Southeast Health Center Expansion

Civic Design Review Phase 3 Submission Package

July 5, 2019

FRONT ELEVATION AT KEITH STREET (NW)

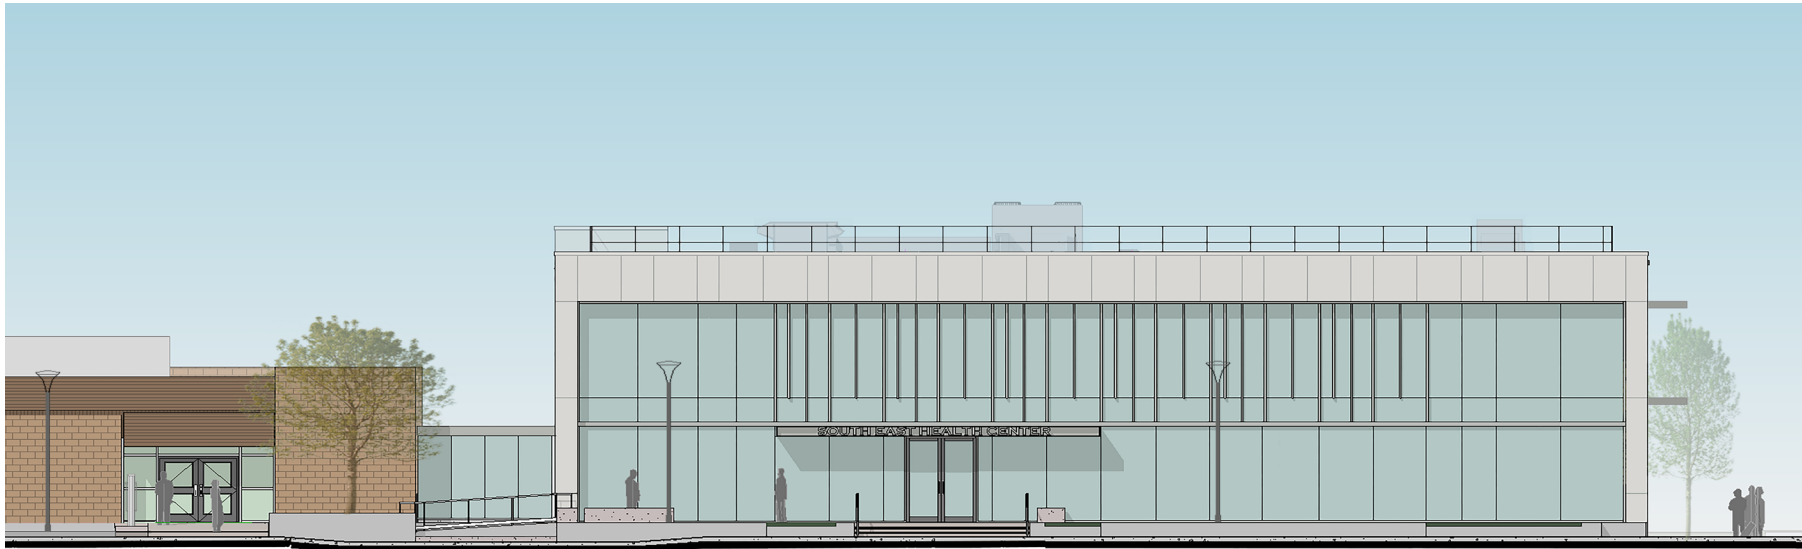
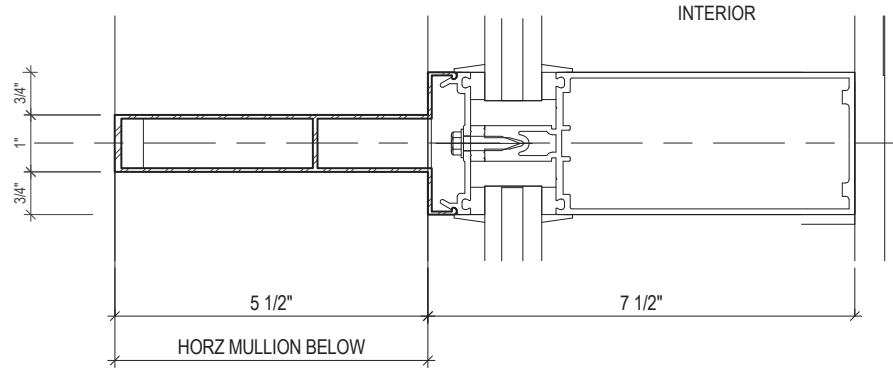
FRONT FACADE SCREEN: RATIONALIZE FIN PATTERN, DEPTH + LENGTH

1 CURTAIN WALL FIN DETAIL-PLAN
6" = 1'-0"

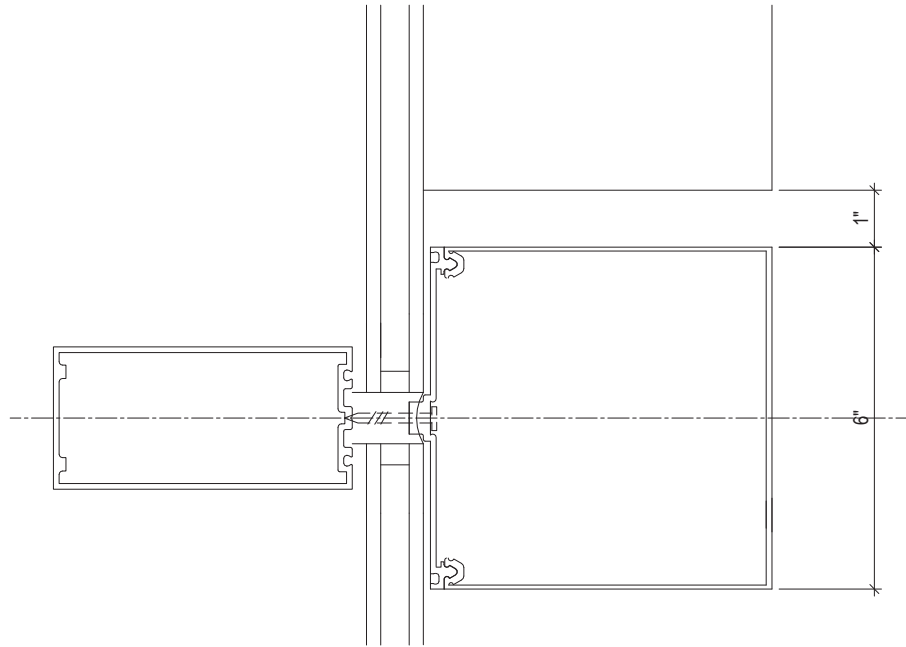
FRONT FACADE SCREEN: RATIONALIZE FIN PATTERN, DEPTH + LENGTH

OVERALL SITE & PLANTING PLAN

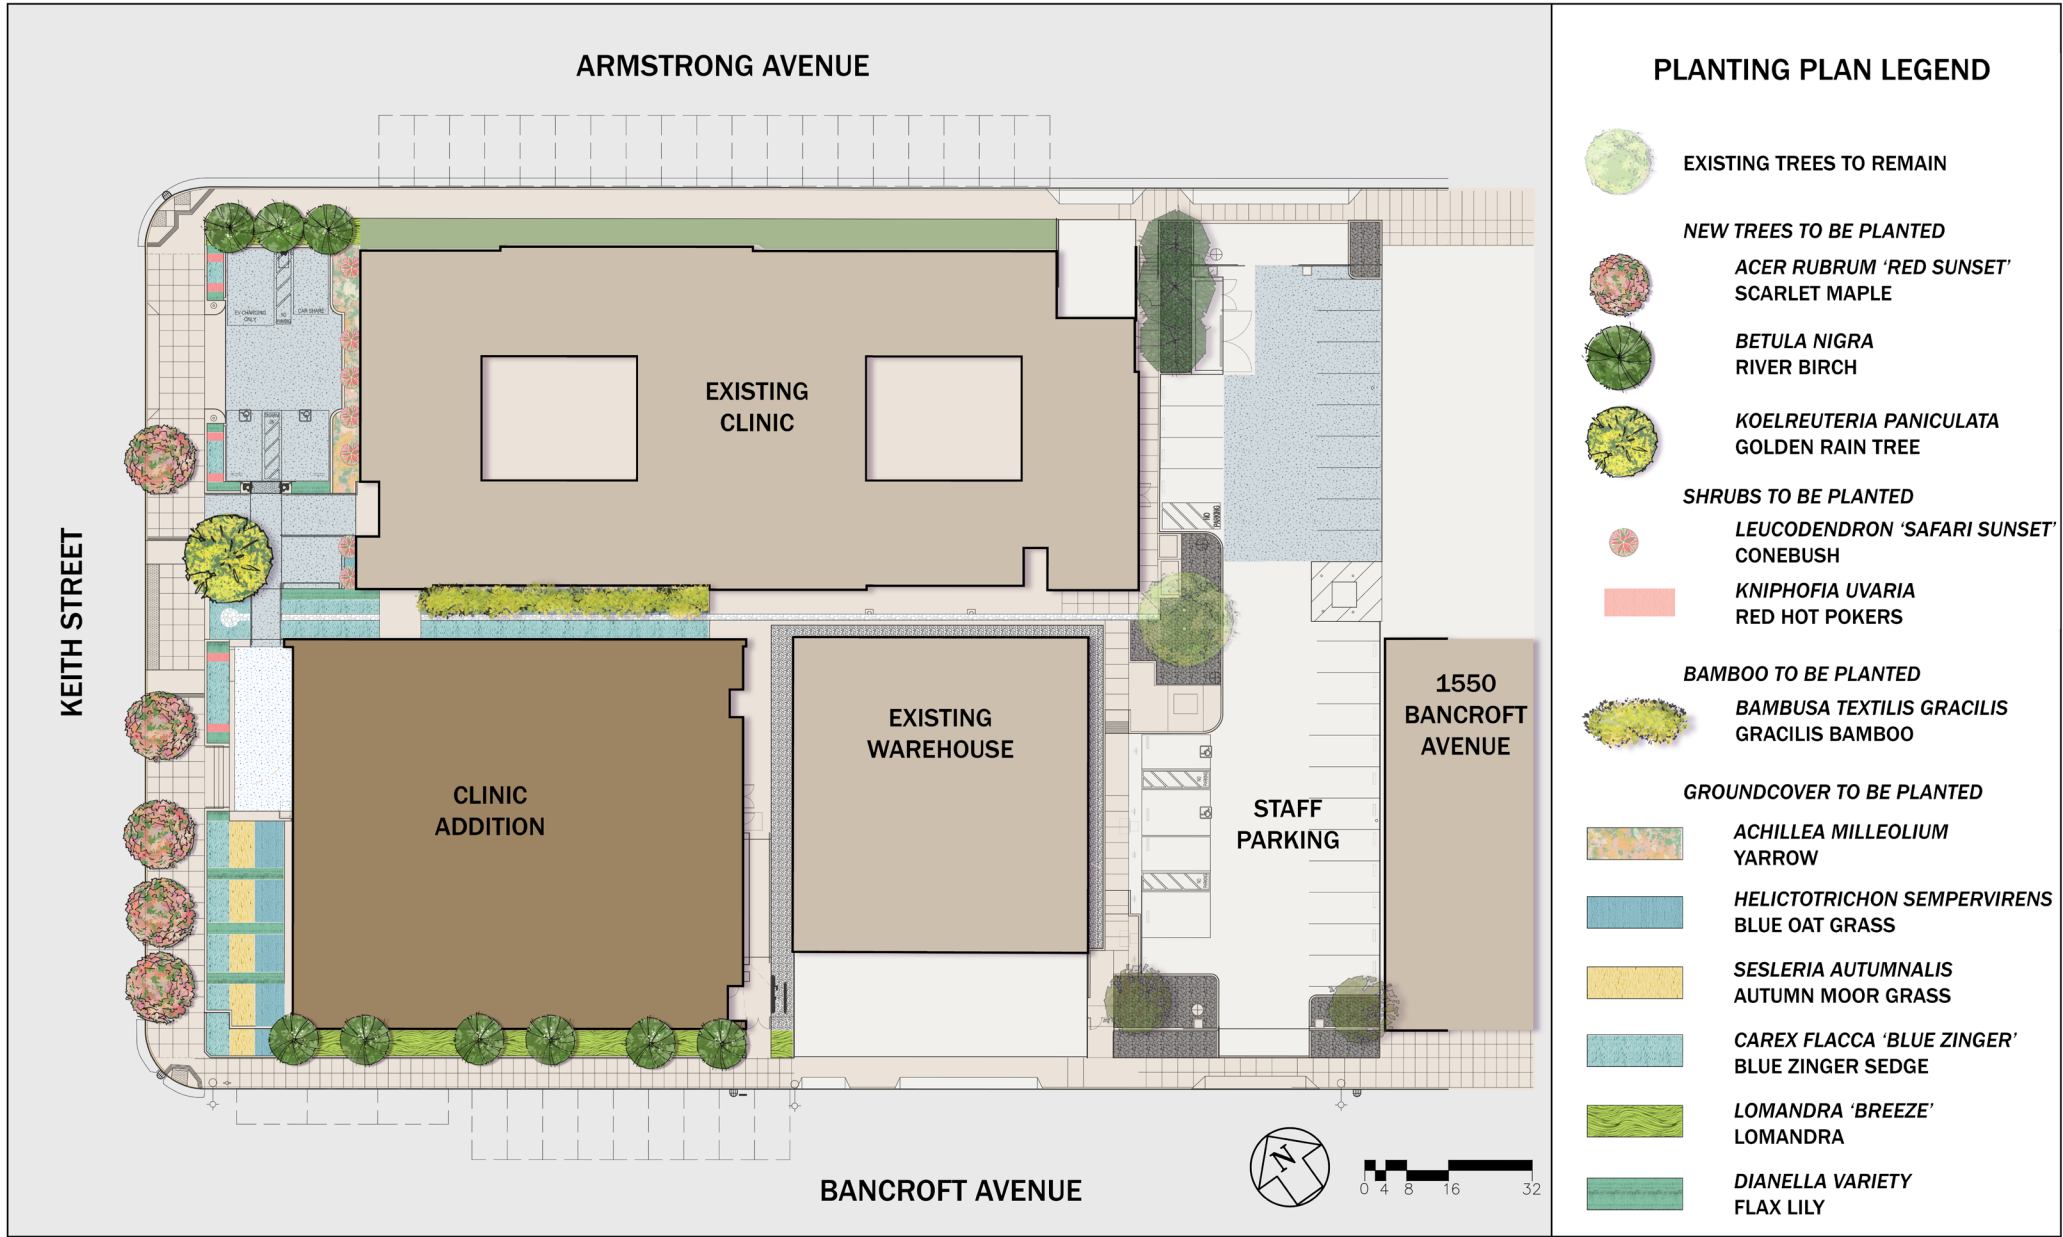
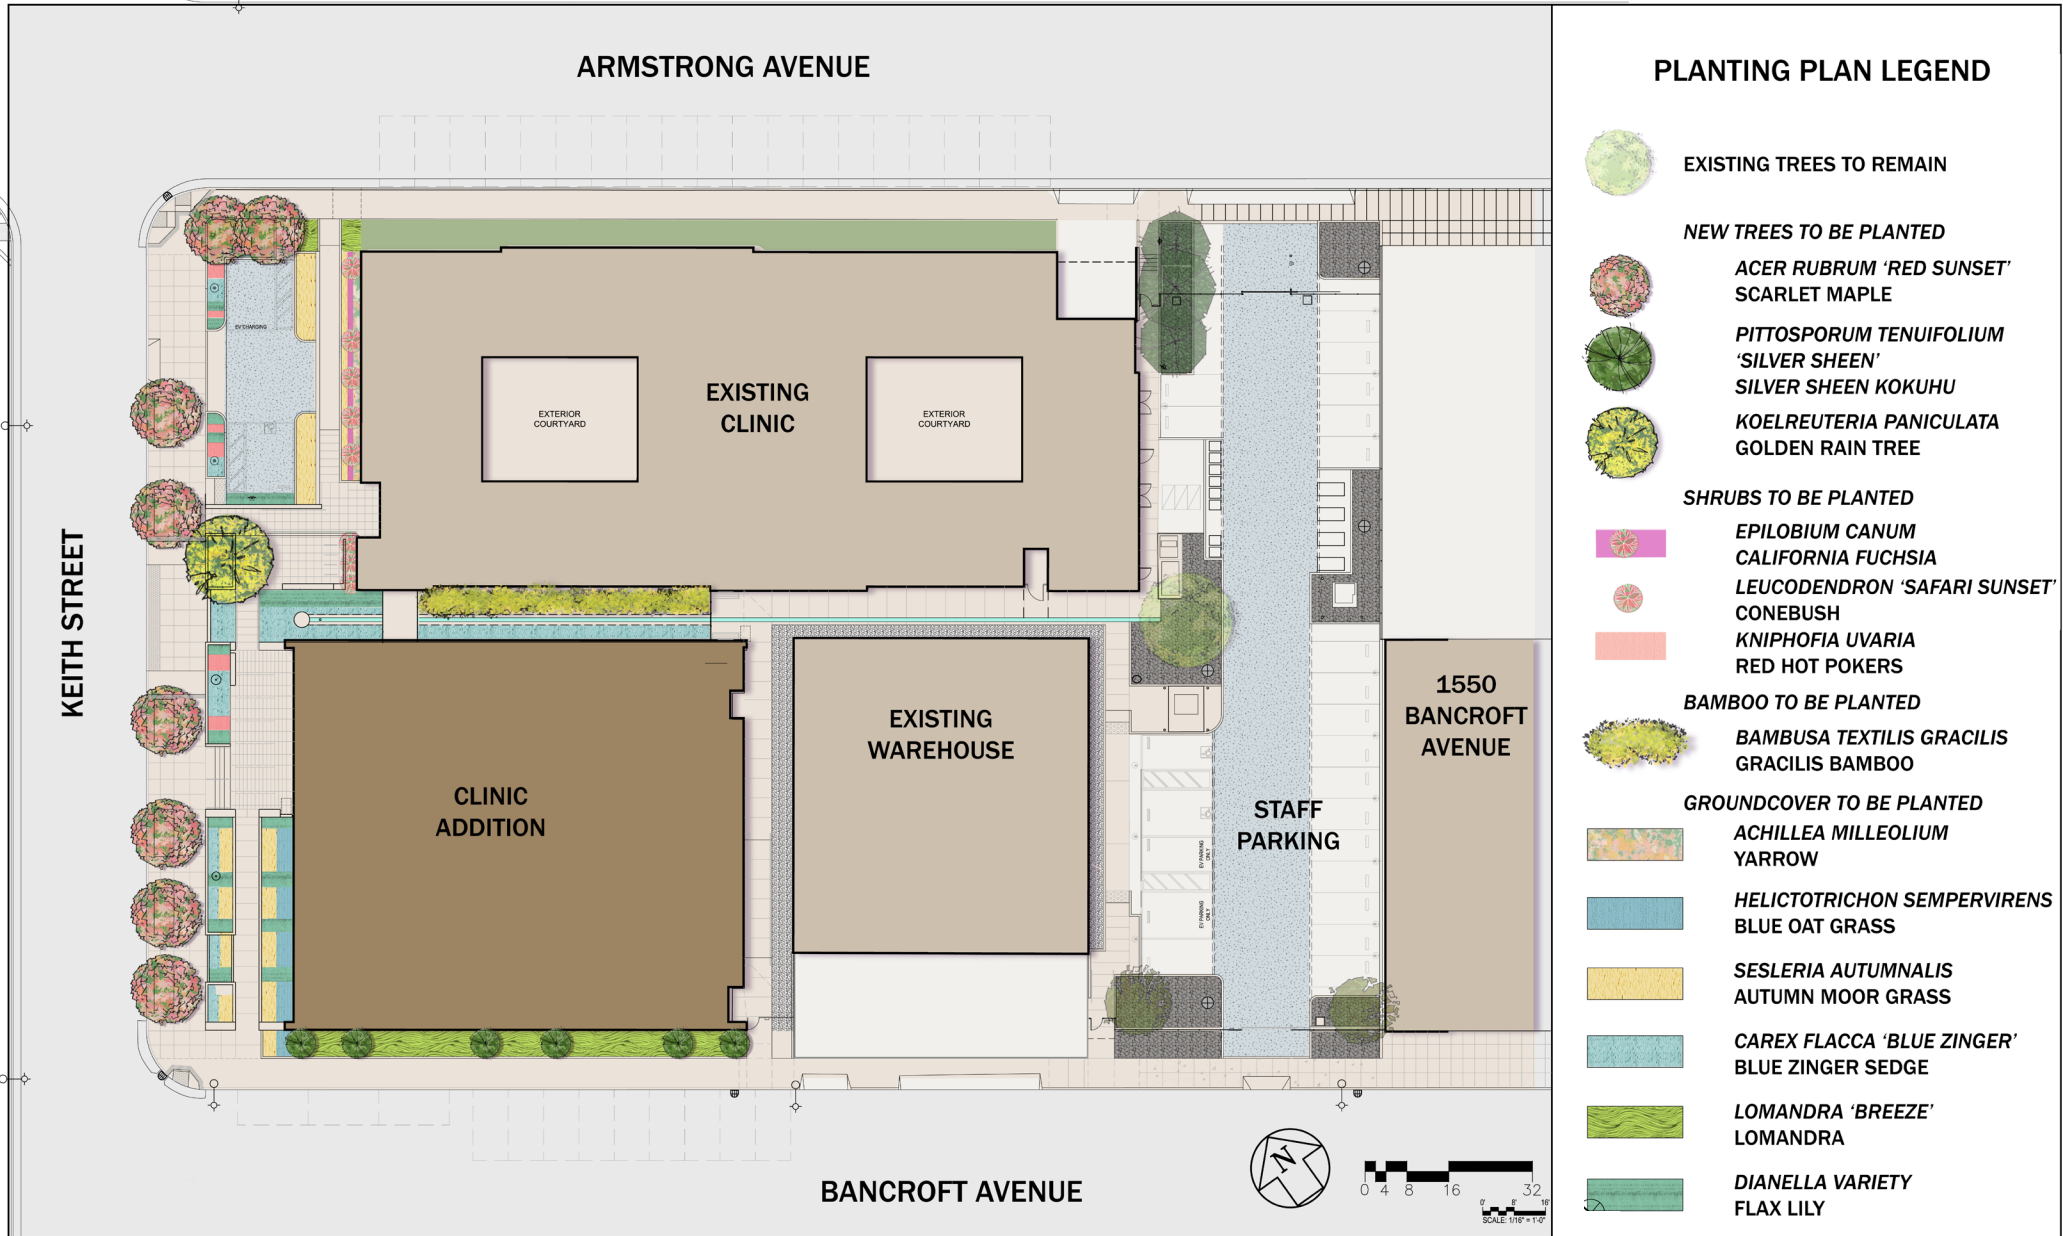
LANDSCAPE RUNNEL: TERMINATE BEFORE RAMP

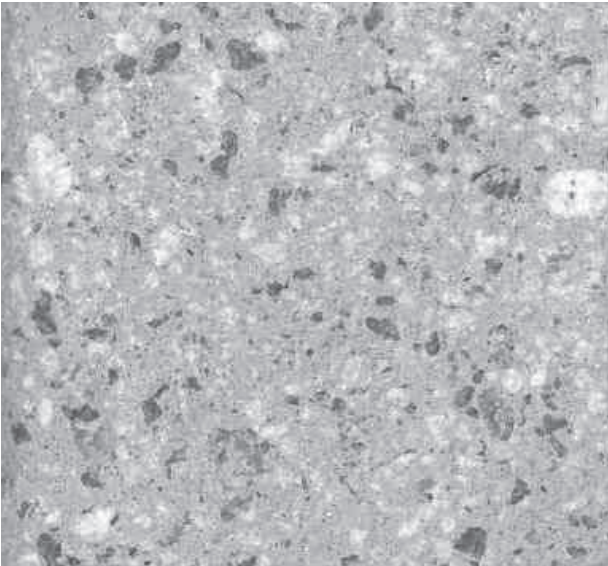
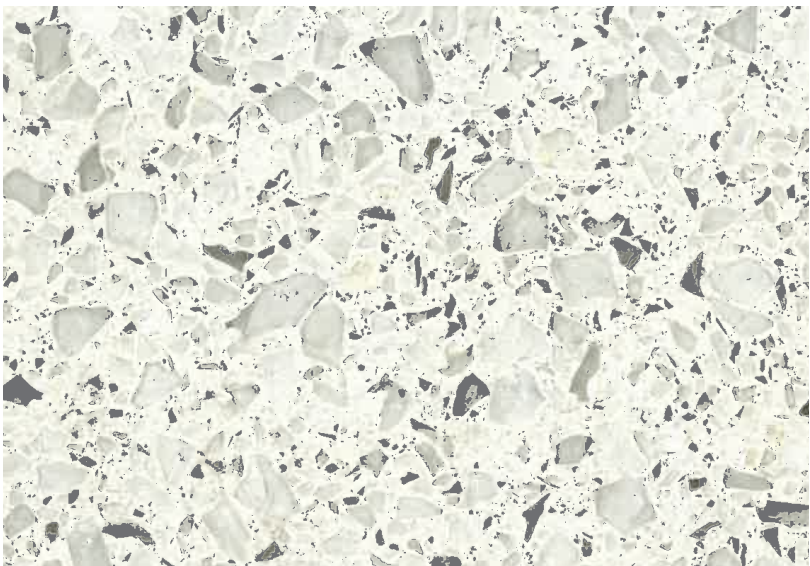
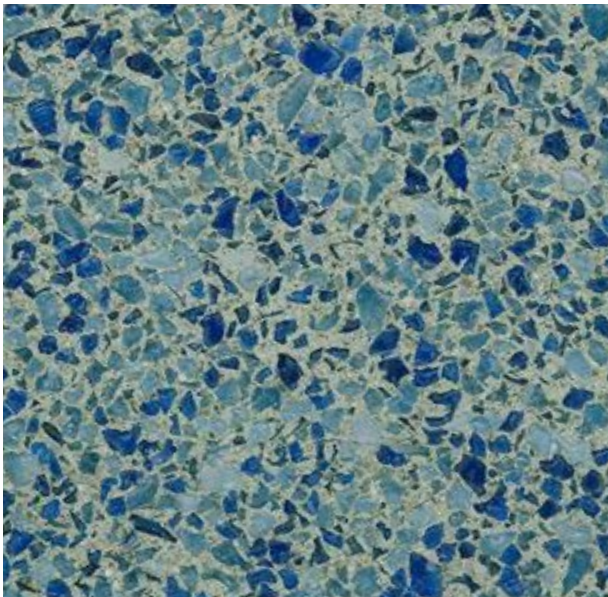
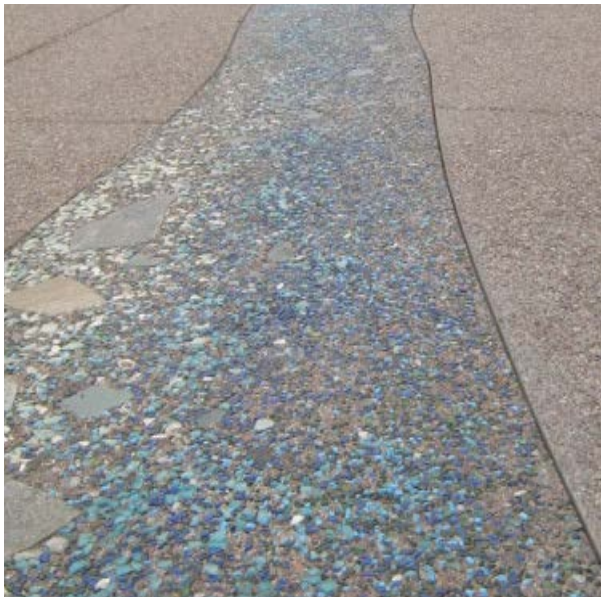
TIE TOGETHER ENTRY PLAZA + LOBBY: CONTINUITY OF MATERIALS

EXTERIOR PAVERS TILED DESIGN - PLAZA

CAST TERRAZZO - LOBBY INTERIOR

CAST LITHOCRETE - PLAZA

RESILIENT TILE - LOBBY INTERIOR

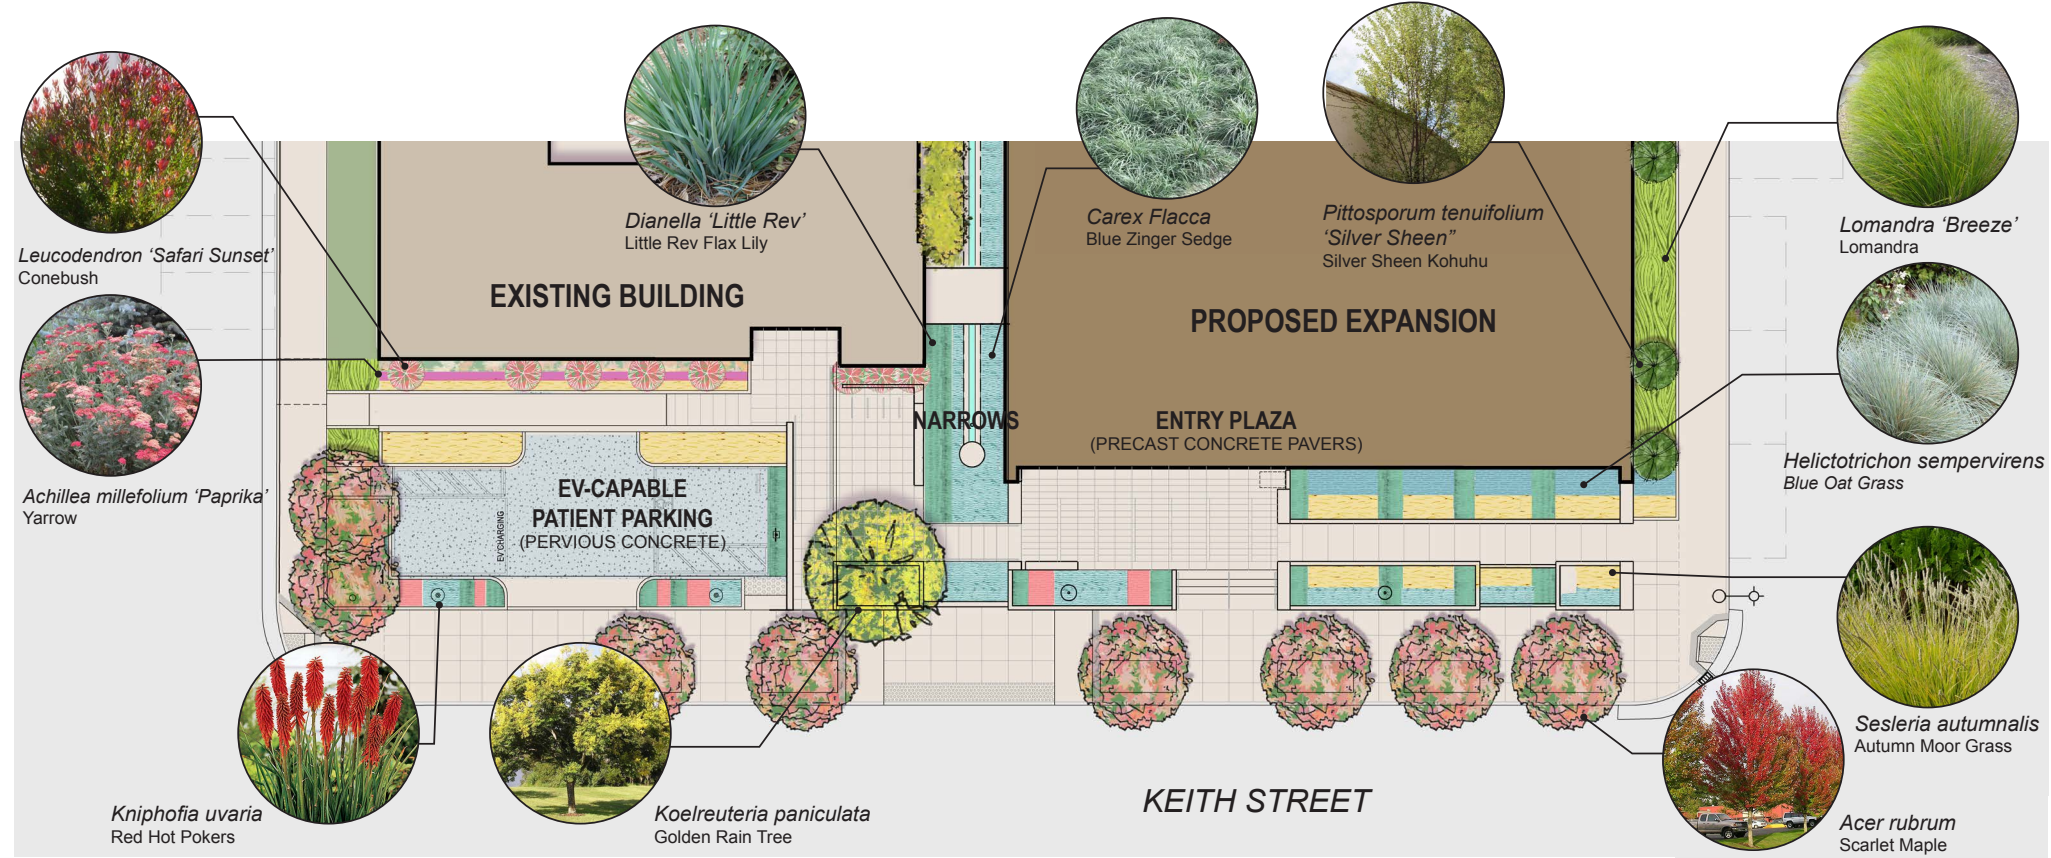
LANDSCAPE: NEW ACCESSIBLE PATH PER COMMUNITY REQUEST
